TR010027 - Application by Highways England for an Order Granting Development Consent for the M42 Junction 6 Improvement

Matters to be responded to in accordance with Deadline 9 of Rule 6 letter dated 8th November 2019

New R15
Altering the Priority of
the Catherine-de-Barnes
Lane and St Peters
Lane Junction

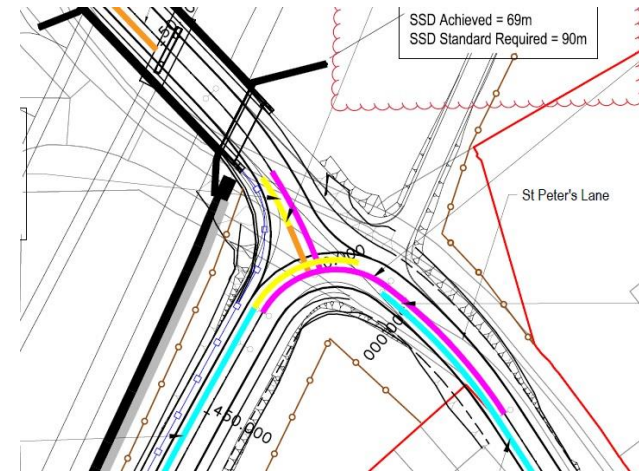
The ExA note that the Applicant has previously considered the altered priority for this junction but discounted it due to the need for a departure from standards for the horizontal radius of the bend onto the northern overbridge, for the consequent visibility round the bend and for the visibility to the left at St Peter's Lane: and, the possibility that the 'straight' alignment might encourage vehicles leaving St Peter's Lane to do so without stopping. The ExA acknowledge that the road layout might need to be altered, but they do not agree that land beyond the Order limits would be required, or that necessary road signs and safety features would clutter the roadside scene (similar signs and features would be required by the current proposal) or that the departure from standards would lead to worse or unacceptable road hazards; the opposite would be the case.

SMBC would not support a change in priority at this junction

SMBC and HE explored 3 design options for the priority at re-aligned Catherine de Barnes Ln/ St Peters Ln junction depending on the available land and taking into consideration the number and severity of the departures from standard that associated with each design option;

Option 1; priority for traffic on re-aligned Catherine de Barnes Lane to St Peters Ln.

Option 1; the priority is for traffic on the re-aligned Catherin de Barnes Lane heading toward St Peters Ln, due to the limited available land for this design layout, this option introduced a sharp bend on Catherine de Barnes Ln and limited forward visibility. This combination of a substandard layout and short of visibility would create a black spot of accident on this junction. In total there would be 11 departures from standard on this option.

Option 2 ; priority for traffic on re-aligned Catherine de Barnes lane onto Catherine de Barnes Ln North overbridge

Option 2, Due to the existence of street features including safety barriers and the limited available land, this option introduced sharp bend on Catherine de Barnes Ln and a short stopping sight distance around the corner. This combination of departures would create a high risk of accidents especially for traffic turning right on St Peters Ln. In total there are 8 departures from standard on this option

Option 3; priority for traffic on St Peters Ln to Catherine de Barnes Ln North overbridge – the preferred option

Option 3 has a priority for traffic on St Peters Ln heading toward

<p>Catherine de Barnes Ln North overbridge, with this layout, traffic on the re-aligned Catherine de Barnes Ln has to give way/stop for the traffic on the St Peters Ln. Therefore the sharp bend would have no effect on the traffic manoeuvres around the junction, also traffic intending to turn right onto/out of re-aligned Catherine de Barnes Ln would have good forward visibility, therefore the potential risk of accident on this layout have been reduced to the minimum. In total there are 5 departures from standard on this option</p> <p>SMBC therefore support Option 3</p>
14		<p>It is agreed that the relocation of the underground storage tank and its access on land to the south of St Peters Lane would not affect the drainage arrangements and that it would be within the Limits of Deviation for Work No.35 [REP6-015]. However, this option is discounted because the access and egress would require a departure from standard and those defects (the provision of a layby off the realigned Catherine-de-Barnes Lane) are deemed to entail an increased risk of fly tipping and unregulated taxi parking. The ExA consider that those impediments could be avoided with measures within the dDCO. Moreover, this option has the advantage of locating the drainage arrangements to a roadside rather than introducing them to an otherwise relatively secluded area; the access to the fields and the aqueduct on the northern side of St Peters Lane need thus only be to an agricultural standard. Hence, the ExA propose the insertion of a new R16 as follows: 16(1) Notwithstanding the details shown on any Certified Plan listed in</p>	<p>We have not been able in the short time to be able to obtain a response from our expert Officers but we could provide more feedback within 2 weeks if this was helpful</p>

15(1) Notwithstanding the details shown on any Certified Plan listed in Schedule 11 of this Order, no part of the realignment of Catherine-de-Barnes Lane is to commence until a scheme for the northern junction of St Peter's Lane and Catherine-de-Barnes Lane has been submitted to and approved in writing by the Secretary of State, following consultation with the relevant planning authority on matters related to its function.

(2) Unless otherwise agreed by the relevant planning authority, the scheme must change the vehicular

junction priority from St Peter's Lane to the realigned section of Catherine-de-Barnes Lane.
